**RE: Response to Comments**  
**Crawford Station Former MGP Site – SSWP, Addendum 3, Revision 0, Group IV Parcels**  
The Peoples Gas Light and Coke Company  
**CERCLA Docket No. V-W-08-C-917**  
**CERCLIS ID – ILN000510192**

**RE:** Response to USEPA Comments  
Site-Specific Work Plan, Addendum 3, Revision 0, Group IV Parcels  
Crawford Station Former MGP Site, Chicago, Illinois  
The Peoples Gas Light and Coke Company

FIGURE NO. 20B

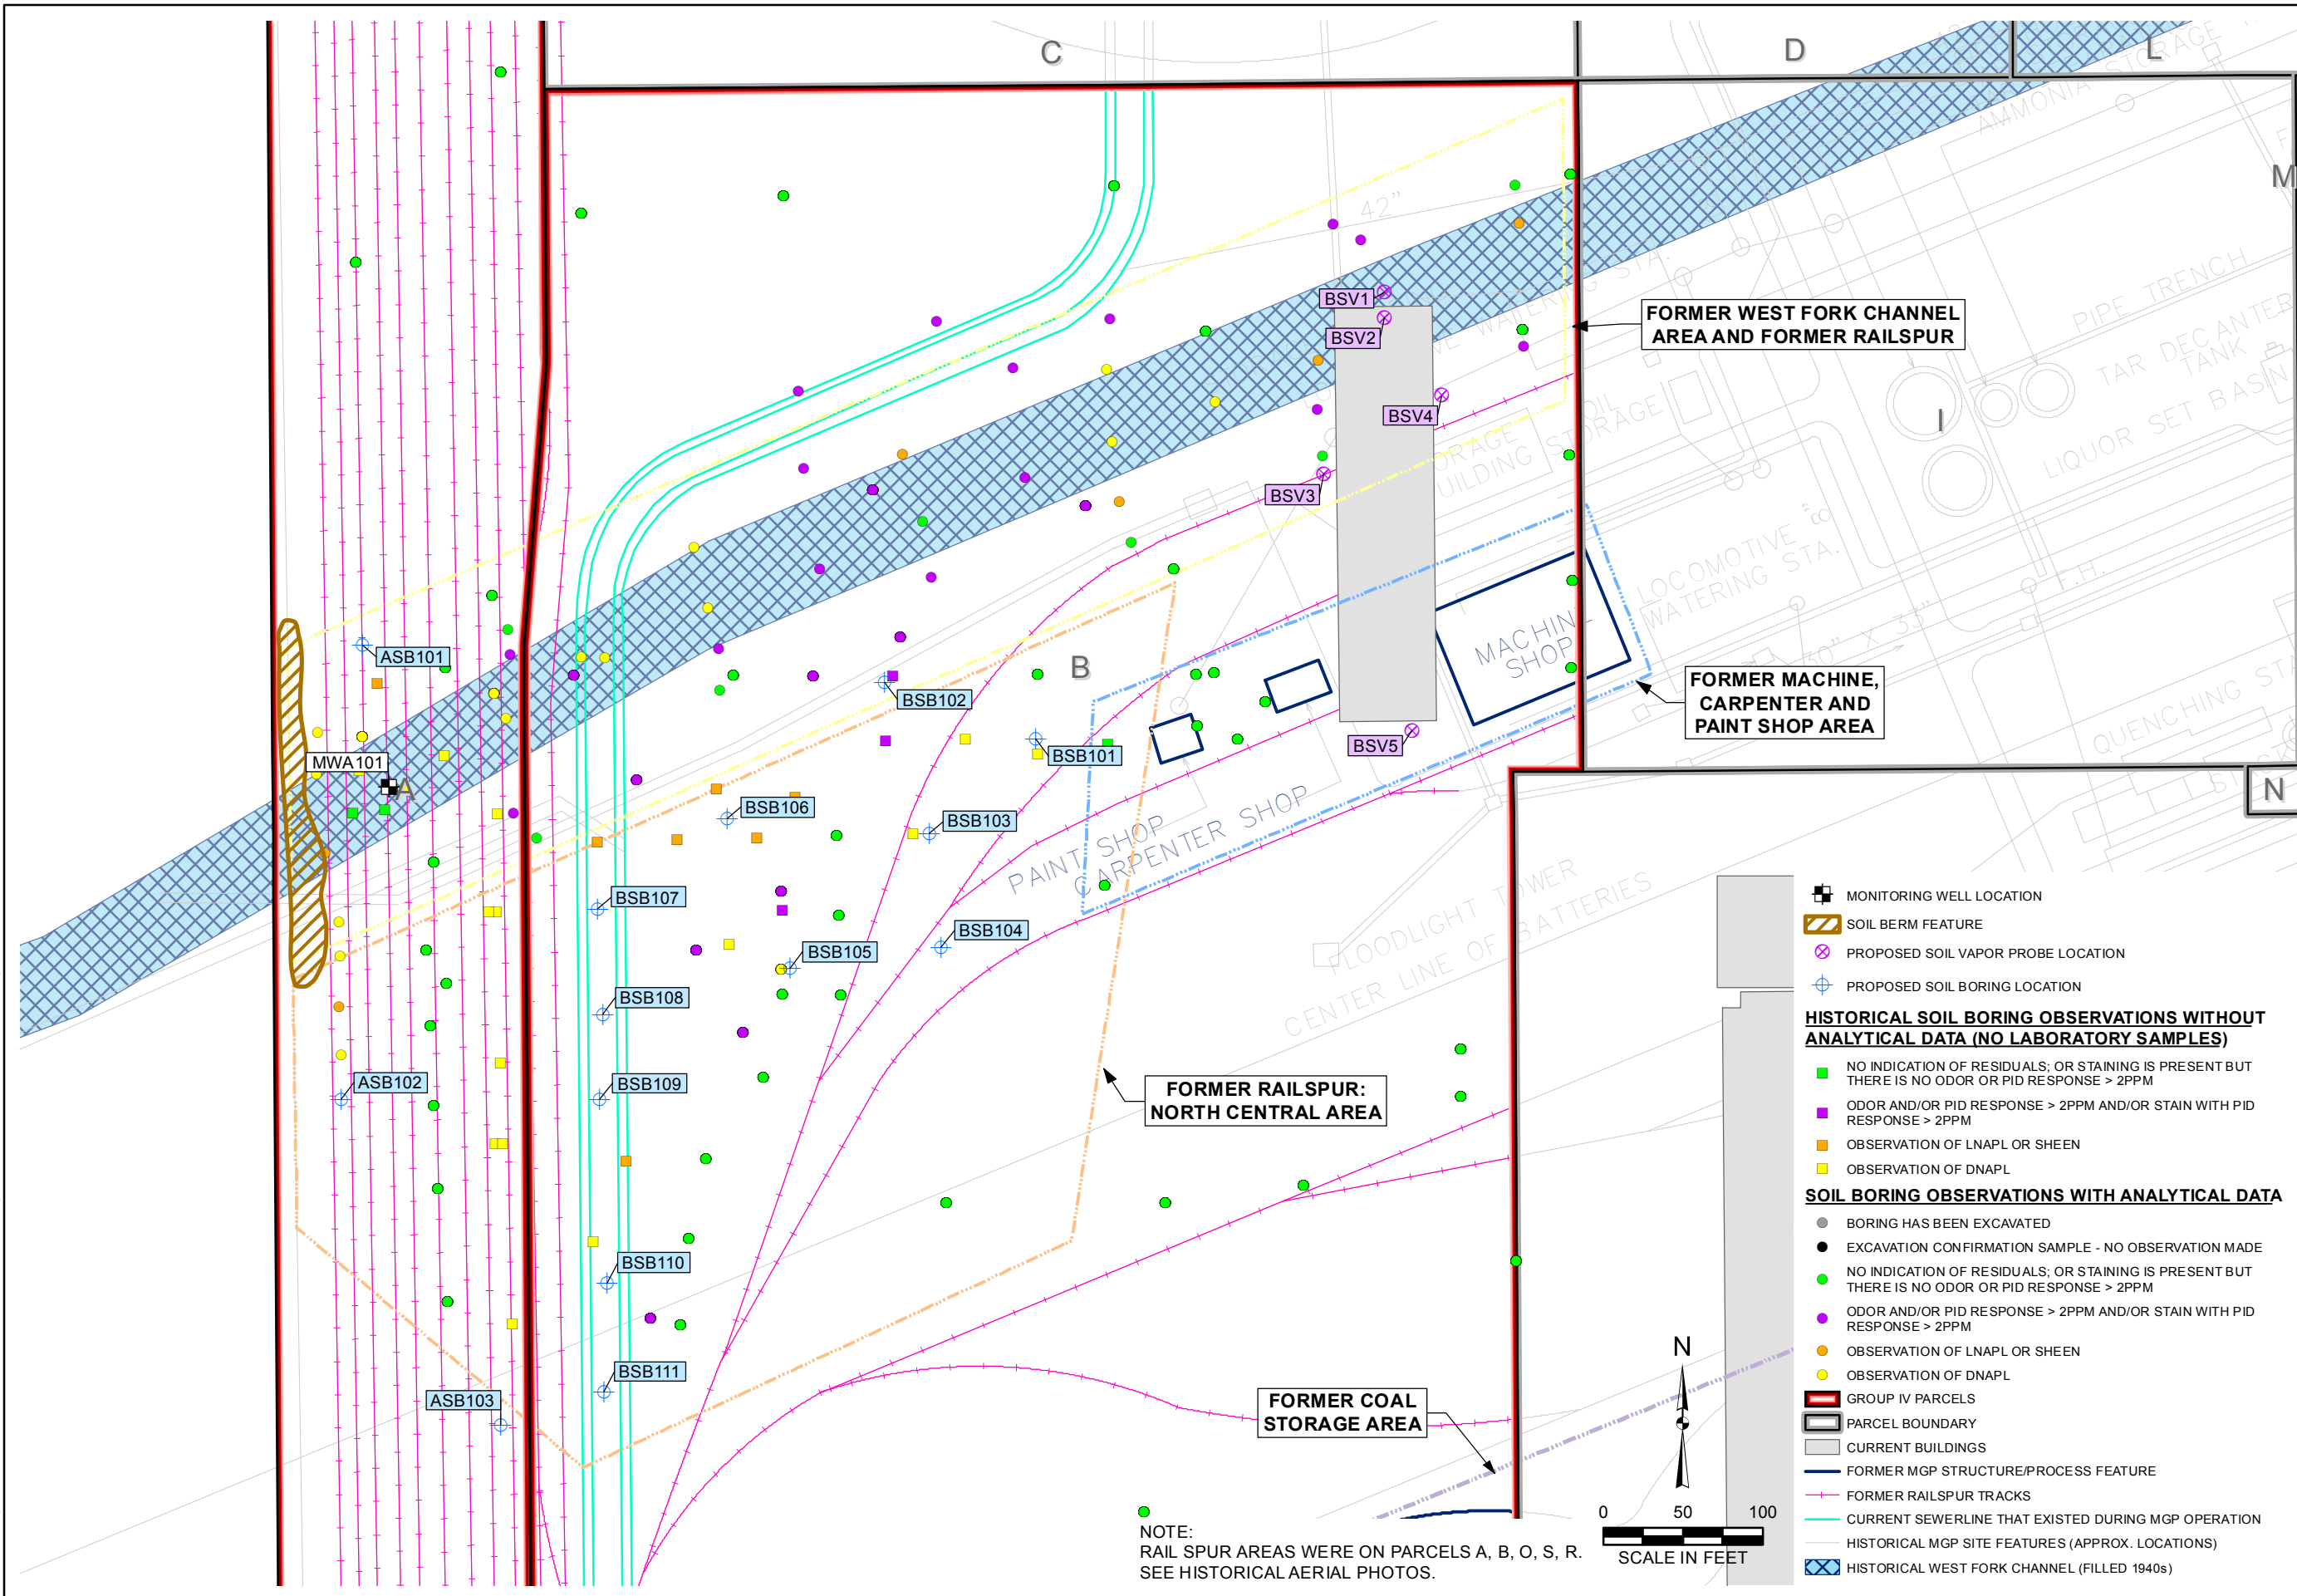
18. **Figure 20B:** *Please add a boring at the western border of the site within the area of the former West Fork Channel. There are orange and yellow designated borings (evidence of NAPL) that are not delineated to the west. However, this work plan includes a boring and monitoring well installation at location PA101S (shown on Figure 21) to address a prior EPA comment (Group I RI) that the current monitoring wells along the former West Fork Channel are not properly screened to monitor potentially migrating NAPL. Therefore, the PRP may consider moving boring PA101S (and the related well nest) to the western property boundary (but still within the former West Fork Channel) in order to both delineate soil impacts and provide proper groundwater monitoring locations along the western border within the former West Fork Channel.*

**Response to SC 18:** Well PA101S will be placed as far west as safely possible. Please note that a steeply sloped, uneven berm is present on the western edge of the property that prevents access to the property edge and fenceline. During the Group II RI, a GPS survey of the top and toe of the berm was completed and now is shown on Figure 20B. Installation of borings west or on top of the berm is not logistically possible.

19. **Figure 20B:** *There are also 4 contiguous boring symbols with yellow or orange coloring (evidence of NAPL) just to the south of the former West Fork Channel and to the north of proposed boring ASB102. These 4 locations do not have a boring to the west, at or near the property boundary, to delineate the apparent NAPL impacted borings. An additional boring appears necessary in this area.*
